2006 303(d) List Update

Central Valley RB Staff Comments

Sacramento River Above Dunsmuir

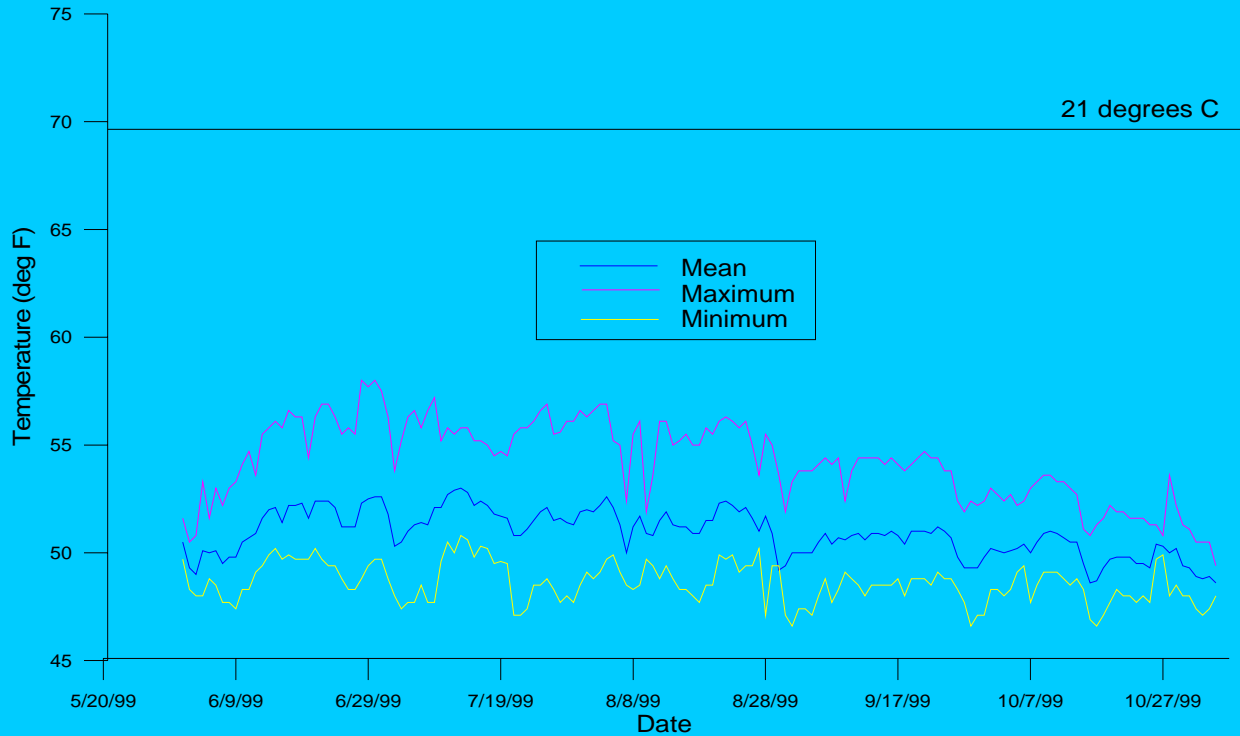
- “Natural” temperature can not be altered unless beneficial uses are not adversely impacted
- 21°C criterion used cannot be achieved in most lower elevation streams
- Baseline for fishery pre-dates major hydro projects
- Upper Sac River example
